Reference: **Contract No. 9727**
I-405, Brickyard to SR 527 Improvement Project

Subject: **Interpretive Engineering Decision for Lateral Migration**

Issue:

Figure 7-6 Total Scour Components with Channel Migration and Abutments

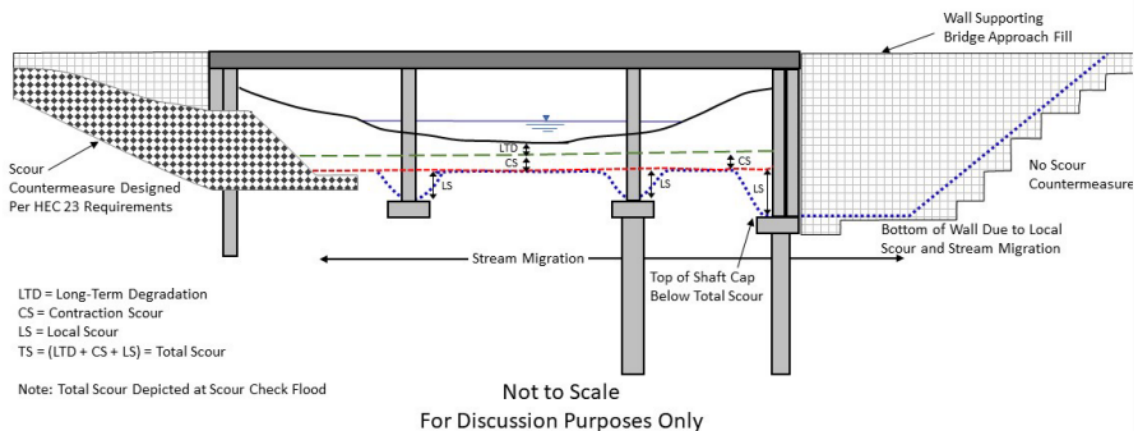
- *But channel migration is anticipated in this case because the risk is defined as “Not Low” and the last sentence does not apply.*
 - *Section 7-4.9 Channel Migration for Structural Design* states:

- Figure 7-6 is detailed below. This shows the scour components and how to define the limits of total scour when there is a risk for lateral migration. Such a risk exists when the risk for lateral migration is determined to be “Not Low”.

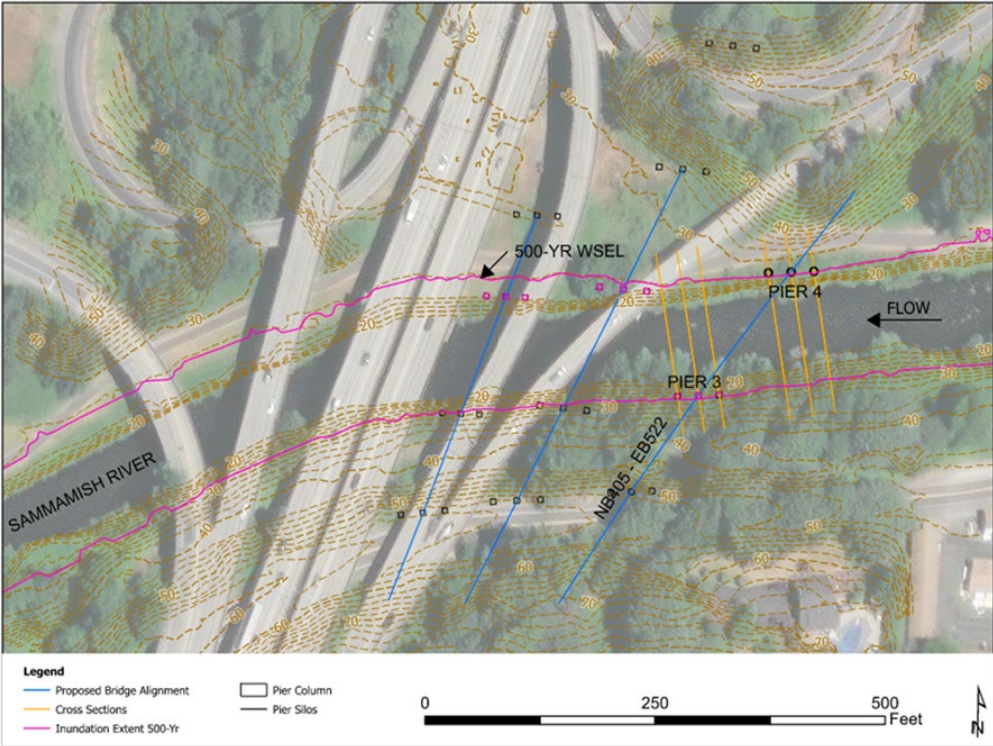
- Page 77 of the Draft FHD identify the piers that are within the 500-year flood elevation, as shown in the graphic below:

The issue of lateral migration of the Sammamish River has been discussed in comment resolution meetings, over the shoulder reviews, and development of the FHD. The contract is clear in RFP Section 2.30, *Water Crossings* that the risk of lateral migration for piers in the 500-year floodplain of the Sammamish River shall be considered “**not-low**”. Because the contract requires the design to analyze the river crossing with this risk level, the hydraulic design is required to assume lateral migration has the potential to occur to any piers within the 500-year floodplain. The design must therefore apply the long-term degradation scour, contraction scour, and local scour in accordance with Figure 7-6 of the Hydraulics Manual – starting at the thalweg elevation straight across then adding the total scour. The current draft final FHD does not comply with this requirement and must be revised to include it.
